**COMMISSION OF ARCHITECTURAL REVIEW
STAFF REPORT
August 23, 2016 Meeting**

9. **CAR No. 16-125** (M. Jarreau) **3005-3007 East Franklin Street
St. John's Church Old and Historic District**

Project Description: **Rehabilitate a multifamily building
and construct new multifamily buildings.**

Richmond 1924-1925 vol. 2, 1925 Sanborn Map

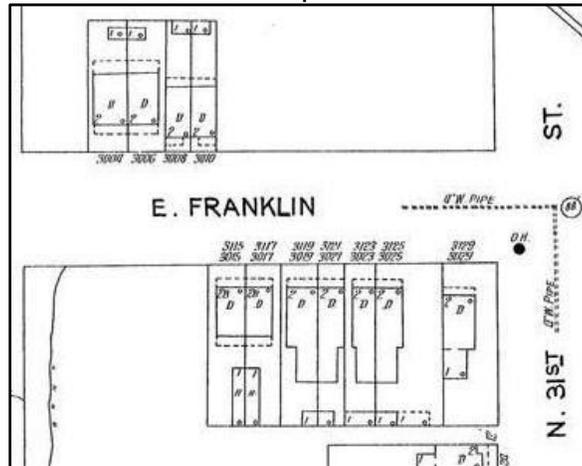
The subject block has been altered through the years, as seen in the Sanborn Map below. The proposed new construction and screen wall restore a building presence closer to the sidewalk as was the historical pattern for the block.
